Catawba Nuclear Station
4800 Concord Road / CN01VP
York, SC 29745-9635

Subject: Duke Power Company LLC d/b/a Duke Energy
Carolinas, LLC (Duke)
Catawba Nuclear Station, Units 1 and 2
Docket Numbers 50-413 and 50-414
Proposed Technical Specifications (TS) and Bases
Amendment
TS and Bases 3.7.8, Nuclear Service Water System
(NSWS)

Figure 1 is a depiction of the existing (dual header) configuration of the NSWS. (Note that all figures contained within this submittal are not drawn to scale.)

Figure 2

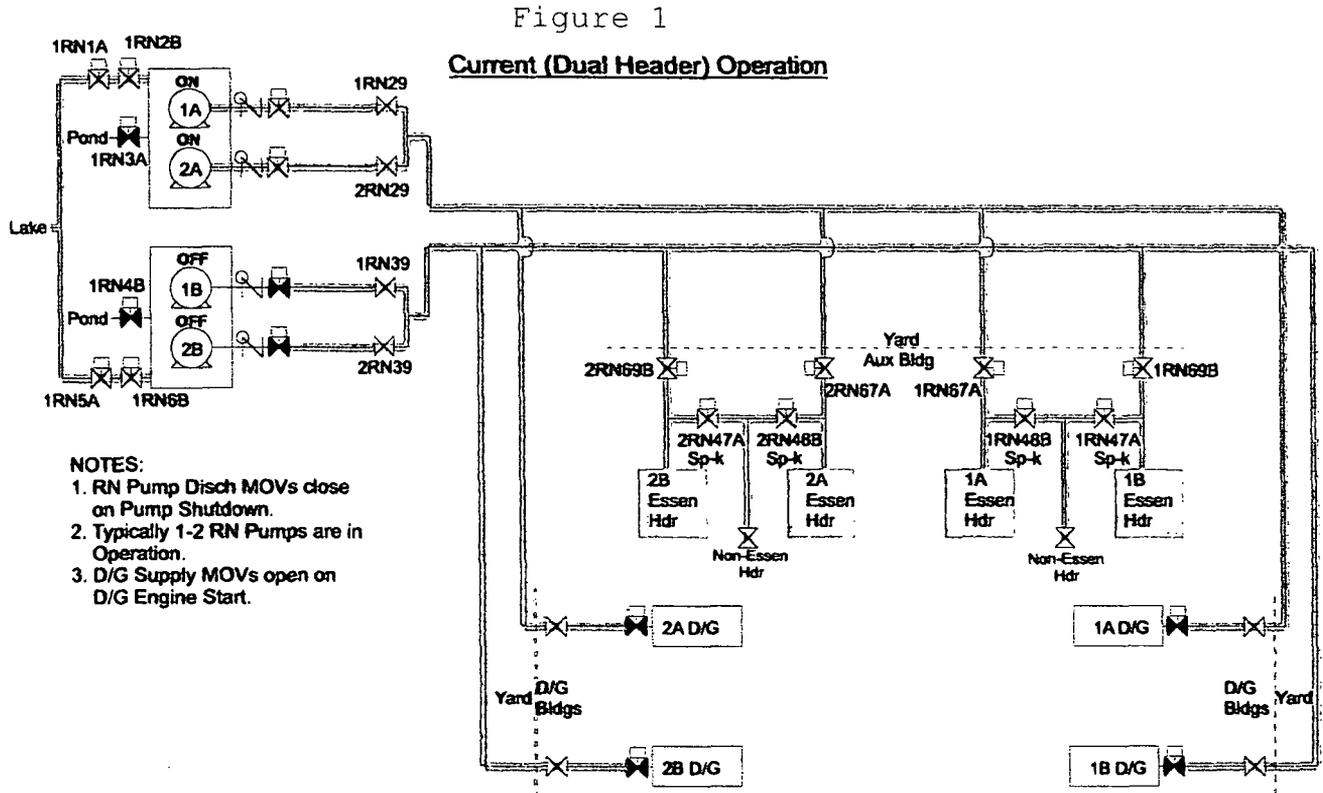
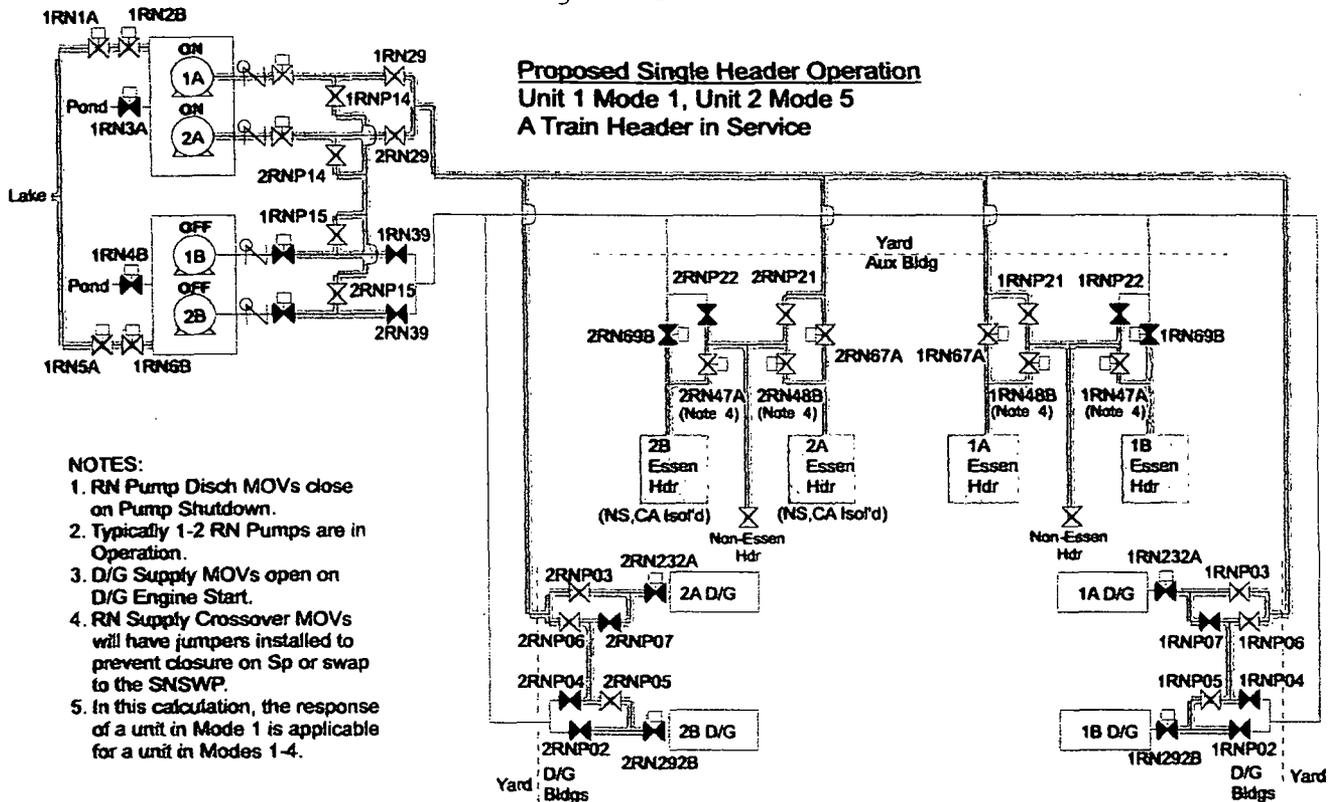
The NSWS single supply header operation proposal involves physical modifications to the system to install crossover piping between trains of supply piping at the pumphouse, in the auxiliary building, and in the diesel generator buildings. During single supply header operation, the system is aligned to direct all flow through one of the two headers exiting the pumphouse, allowing the other header to be removed from service. This alignment redirects flow to each unit's train A and train B headers just inside the auxiliary building and just inside each unit's diesel generator buildings.

Figure 2 is a depiction of the proposed (single supply header) configuration of the NSWS. (Note that all figures contained within this submittal are not drawn to scale.)

In order to support single supply header operation in the auxiliary building and the diesel generator buildings, design changes will be implemented to install crossover piping as shown in Figure 2. This alignment will supply cooling water flow to both trains of both units from the single in-service header. During the response to a LOCA or a loss of NSWs pit level, both trains will remain in service and cross connected. (This is contrary to the existing response to these events where the two trains automatically separate on the affected unit during a LOCA (S_p signal) or separate completely on a swapover to the SNSWP.)

Figure 9

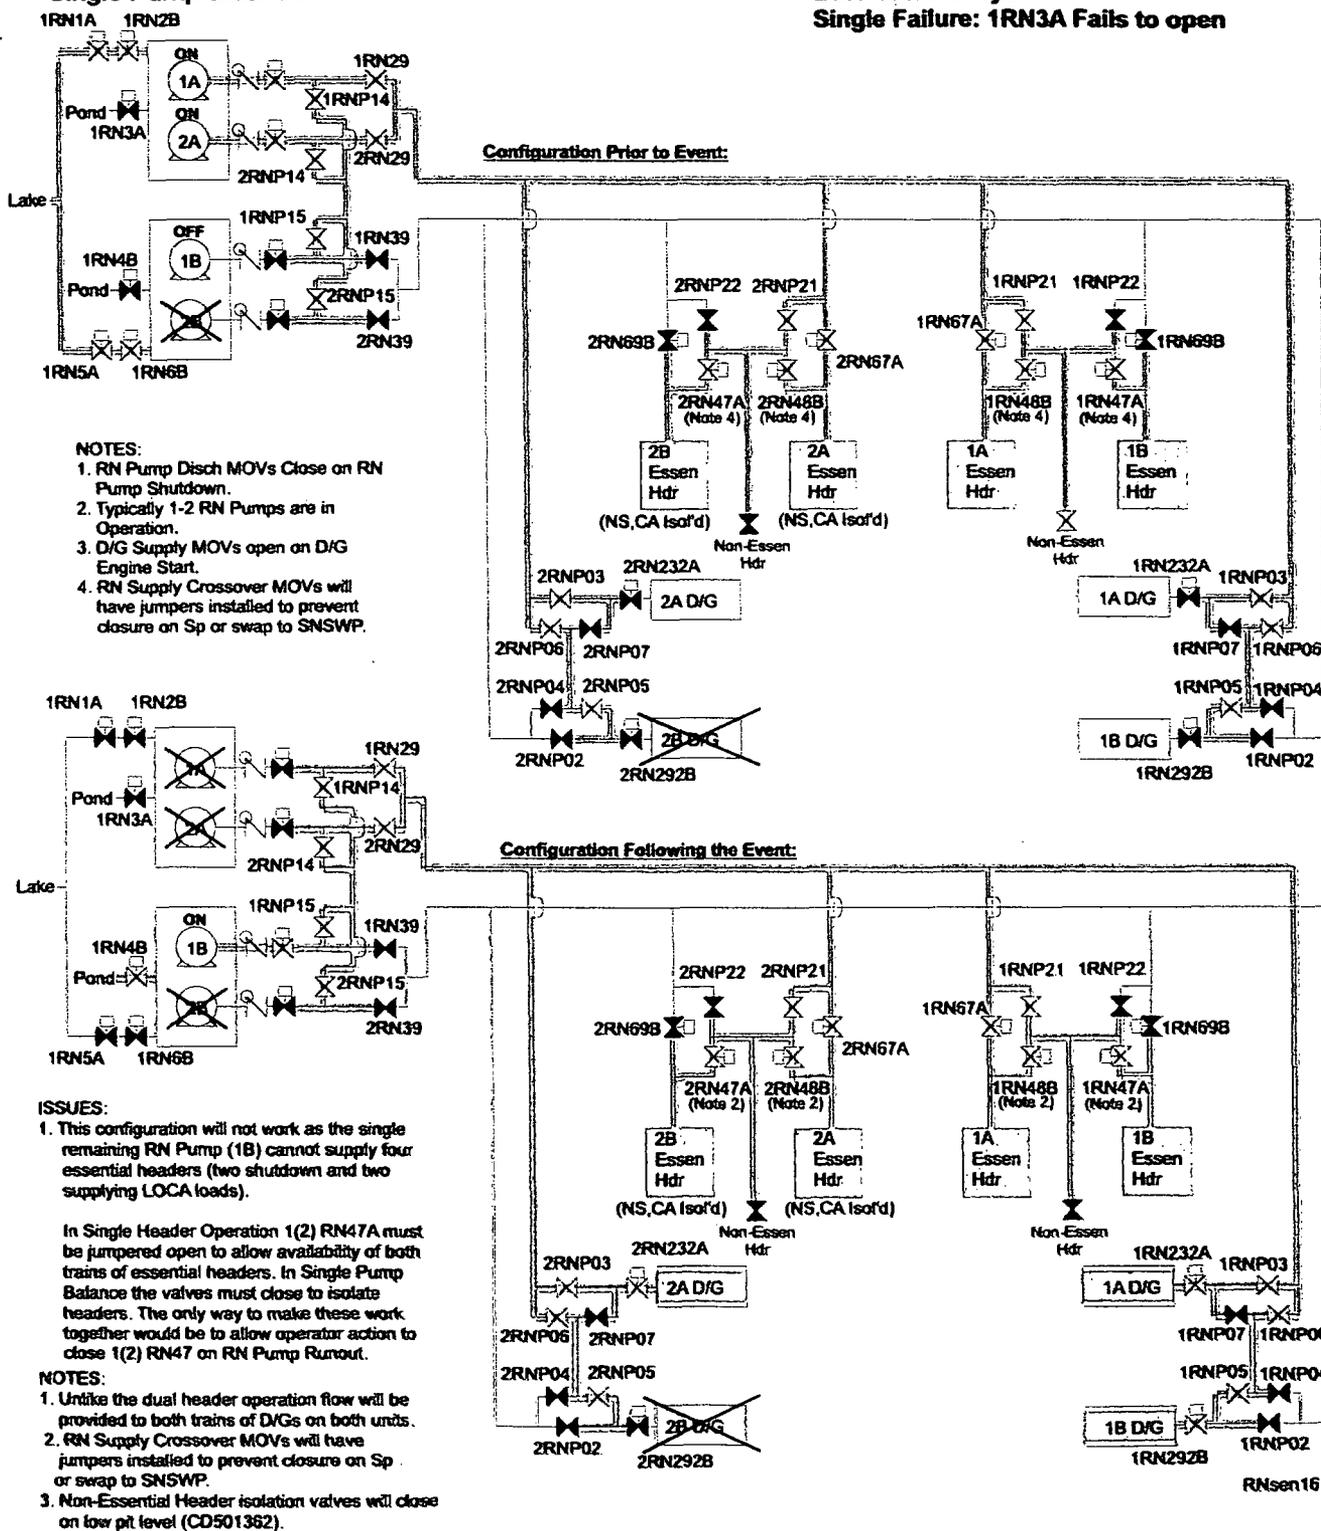
The operational and single failure considerations of Table 1 demonstrate that with the exception of the scenario described in Figure 9, the single supply header alignment meets all requirements of the plant safety analyses. The TS Bases for the NSWS have been proposed to be modified to preclude single supply header operation while in the configuration described in Figure 9 (the single pump balance alignment).
